DEVELOPMENT REVIEW COMMITTEE (DRC) COMMENT REPORT

PROJECT NAME: Rolls Royce / Bentley / Aston Martin Collision Center

CASE NUMBER: R18020

REQUEST: Site Plan Level II Review: 13,973 Square Foot Automotive Repair Shop in Northwest Regional Activity Center

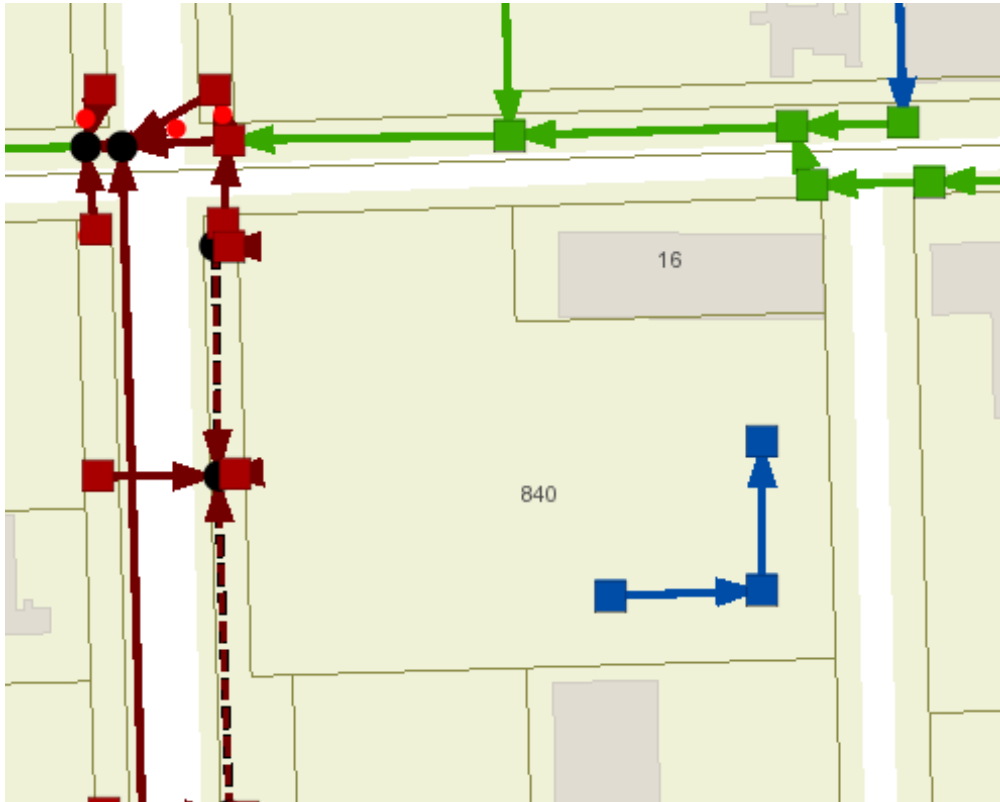
19. The City owns and maintains stormwater infrastructure adjacent to the proposed development as shown in the **Existing Stormwater Asset Map** (green linework) shown below, which may possibly be affected by the proposed development:

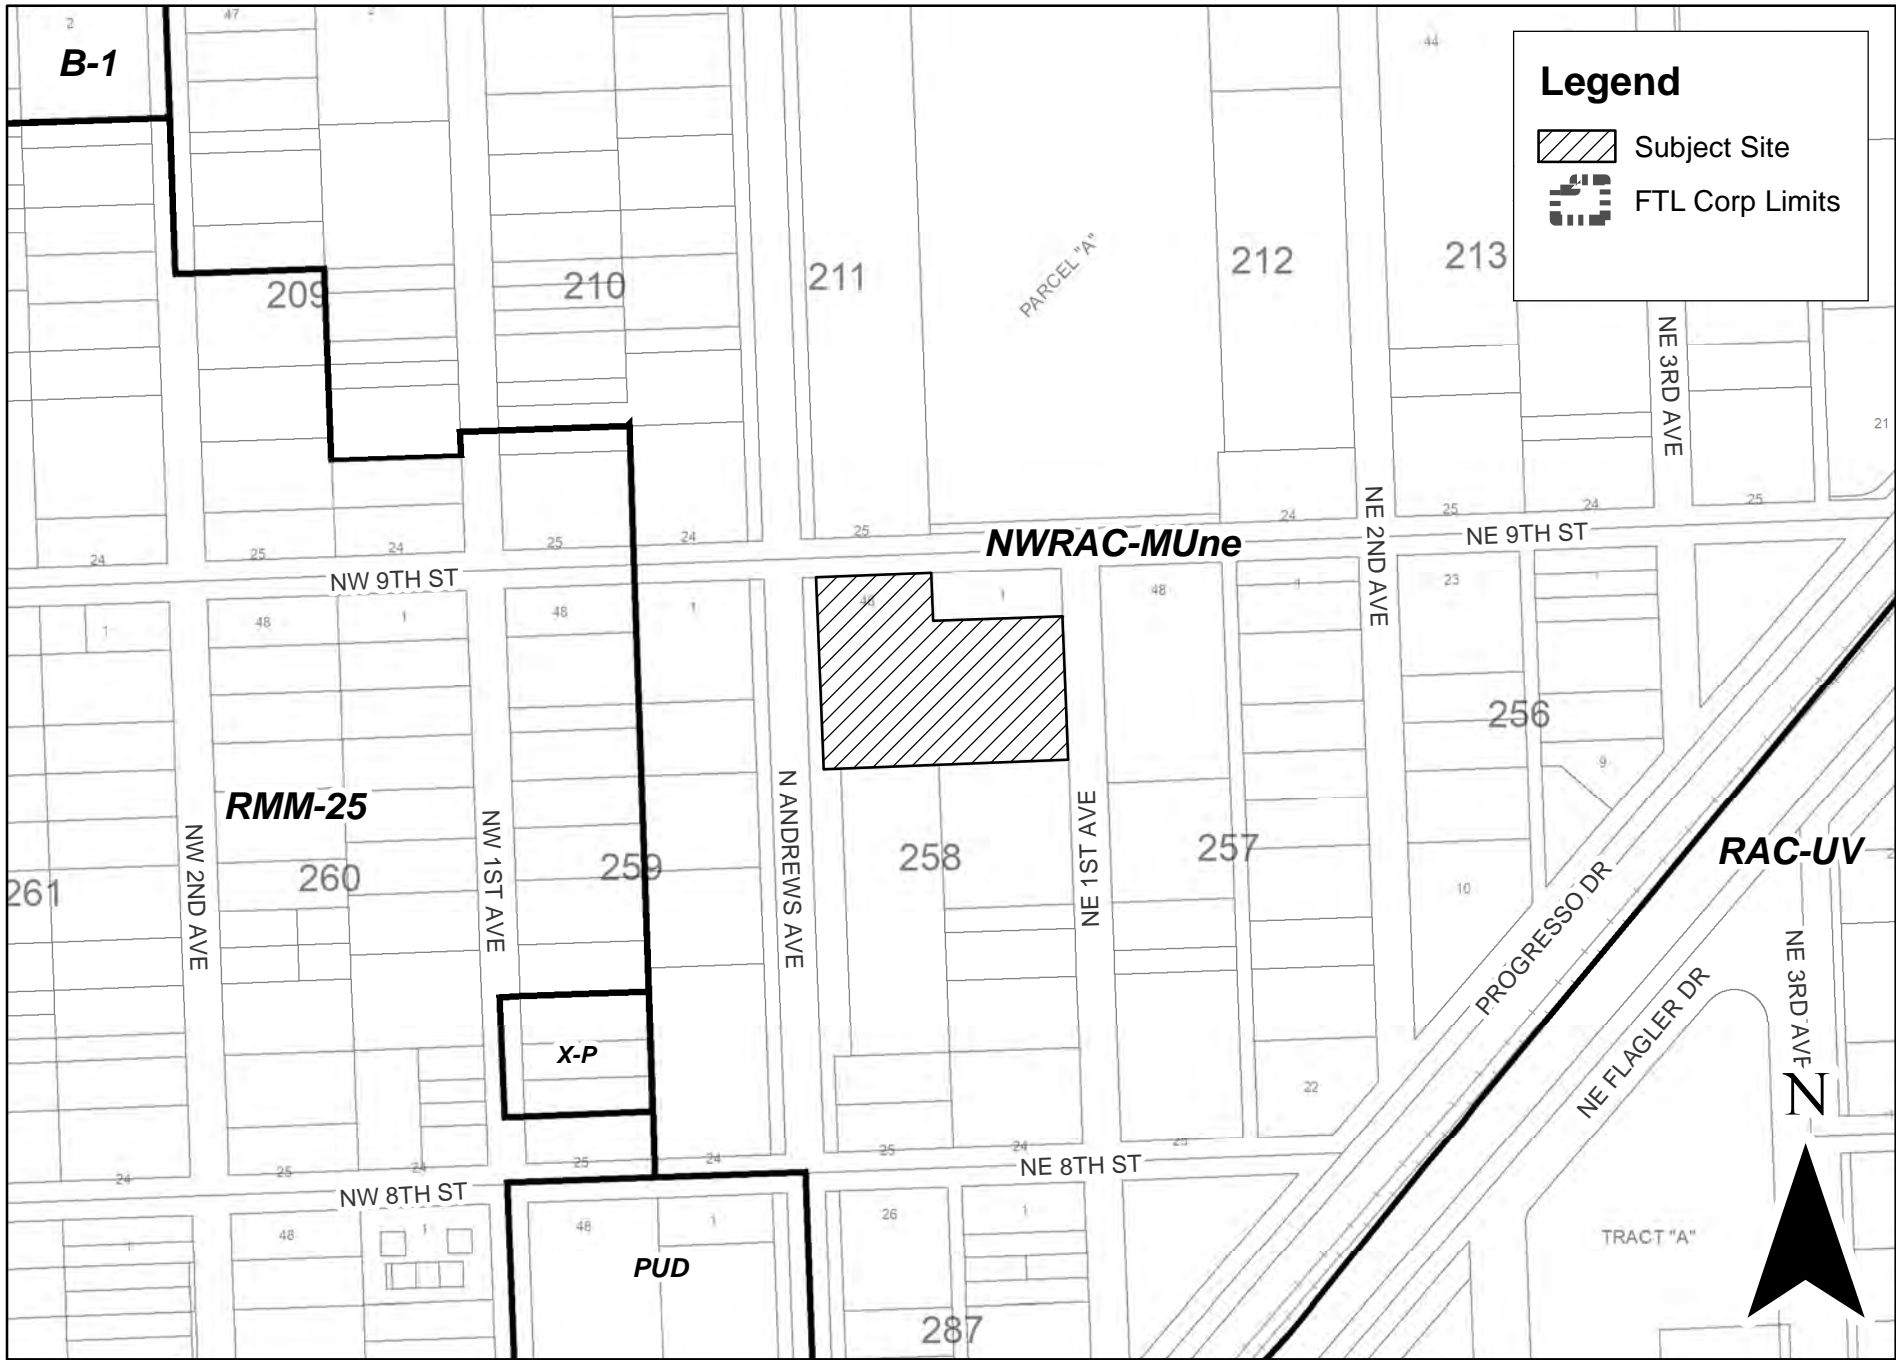
- 10) It is strongly recommended that bicycle parking in visible, well-lit areas as close as possible to pedestrian entryways/doors is provided. In addition where possible, locate bicycle parking facilities in an area that is sheltered/covered. Show internal secured bicycle racks and/or external bike racks on the site plan.
